Access Compliance Report Public Rights-of-Way (Curb Ramps)

Main Street: **MERCANTILE_WAY** Cross Street: **N/A** Location: **N**

ADA ID: **RPRK211029123450** Ramp Type: **Type 1 - Perpendicular** Initial Pass/Fail: **Fail** Overall Compliance: **No** Severity Score: **15**

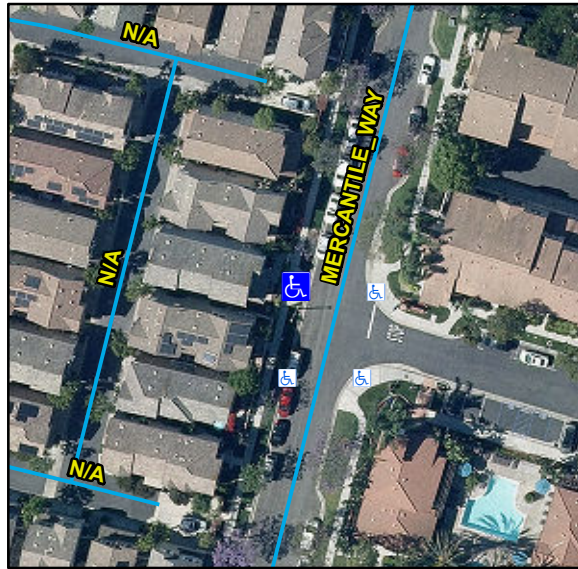
Compliance	Description	Data	Compliance	Description	Data
N/A	Ramp Length (in)	80	N/A	Flare Type LT	
Yes	Ramp Width (in)	48			N/A
Yes	Ramp Run Slope (%)	4.5	N/A	Flare Slope LT (%)	N/A
No	Ramp Cross Slope (%)	5.5	N/A	Flare Traversable LT	N/A
N/A	Landing Present	N/A	N/A	Flare Type RT	
N/A	Landing Length (in)	N/A			N/A
N/A	Landing Width (in)	N/A	N/A	Flare Slope RT (%)	N/A
N/A	Landing Run Slope (%)	N/A	N/A	Flare Traversable RT	N/A
N/A	Landing Cross Slope (%)	N/A	N/A	DWS Provided	N/A
N/A	Landing Movement Obstructed?	N/A	N/A	DWS Contrast	N/A
	Landing Movement Type	N/A	N/A	DWS Length (in)	N/A
N/A	Landing Shared	N/A	N/A	DWS Full Width	N/A
N/A	Clear Space	N/A	N/A	DWS Offset Left (in)	N/A
N/A	Clear Space To Crosswalk (in)	N/A	N/A	DWS Offset Right (in)	N/A
N/A	Marked Crosswalk 1	No	N/A	Marked Crosswalk 2	N/A
	Crossing 1 Direction	SE		Crossing 2 Direction	N/A
	Marked Crosswalk 1 Width (in)	N/A		Marked Crosswalk 2 Width (in)	N/A

Remove & Replace Entire Ramp.
